BLM SCALAR FIX -Based on findbhudda's original design:
<http://www.midibox.org/dokuwiki/doku.php?id=findbuddha>

Corrected blm-scalar v1.1.brd below & attached: [blm-scalar_v1.1.zip](#)

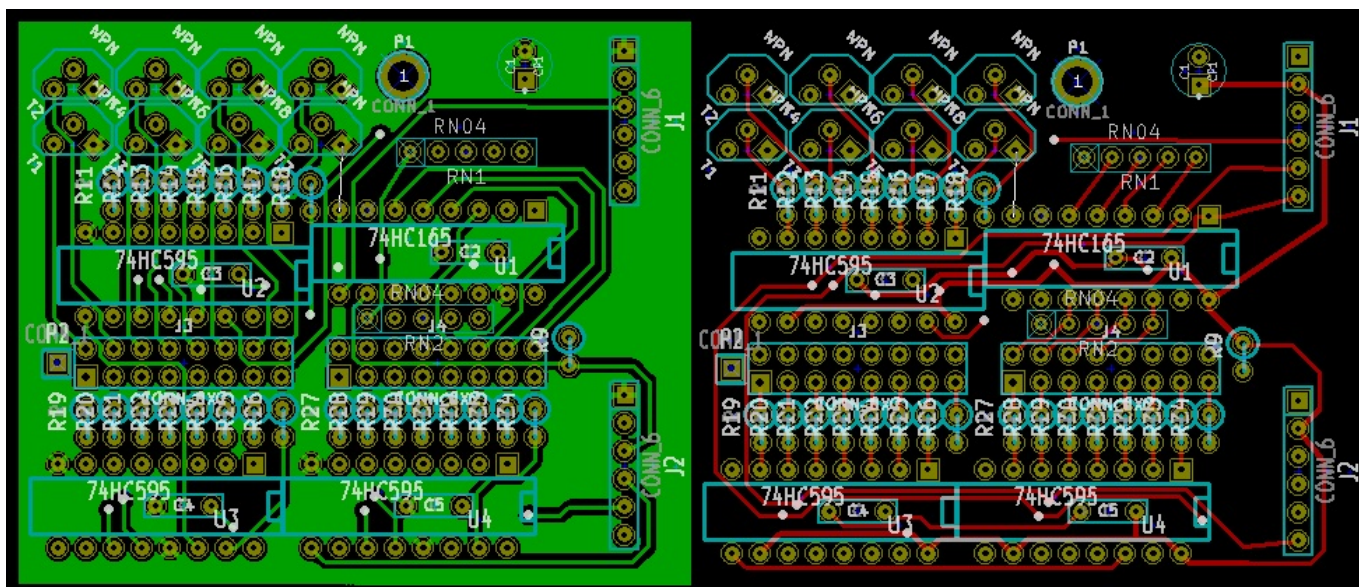
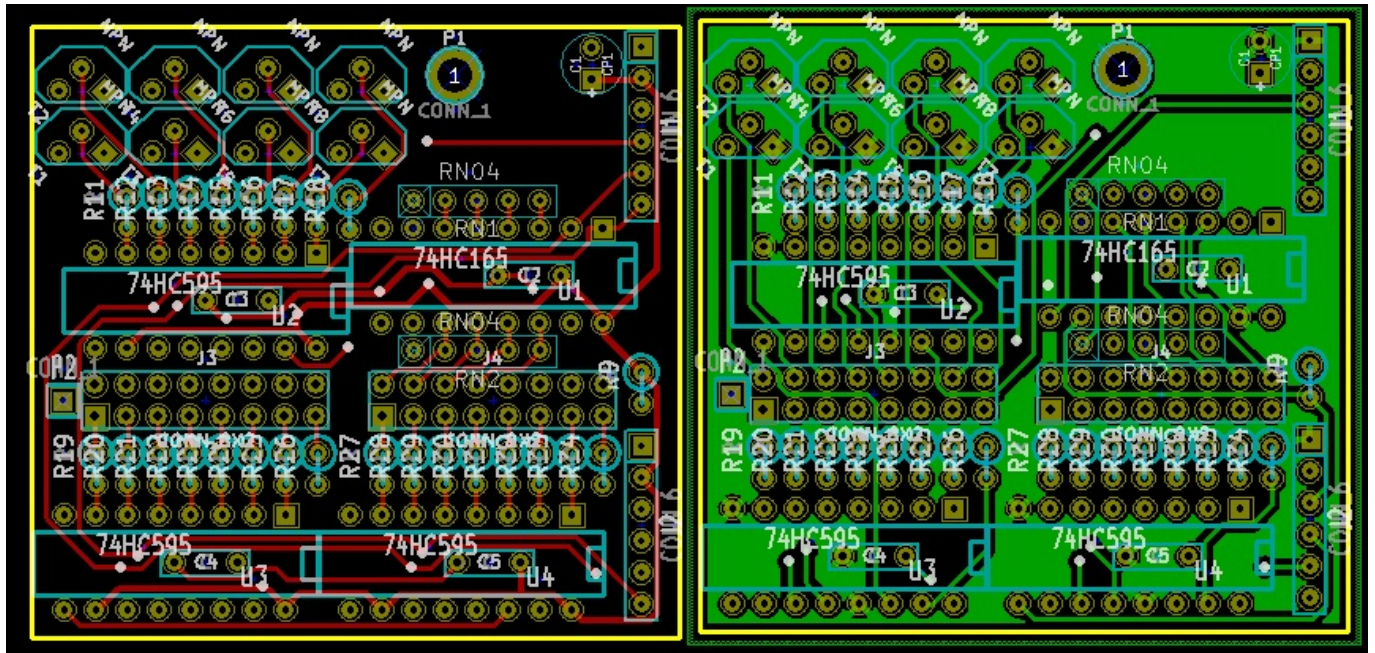
- blm-scalar.* contain an error. Pins I4-I7 are mirrored. This is easily fixed with a connector modification, and the blm-scalar module seems to work as intended.
- blm-scalar v1.1 attempts to fix this error. Moved connectors J1, J2, Resistor Net 1 and R9 to make room for corrections.
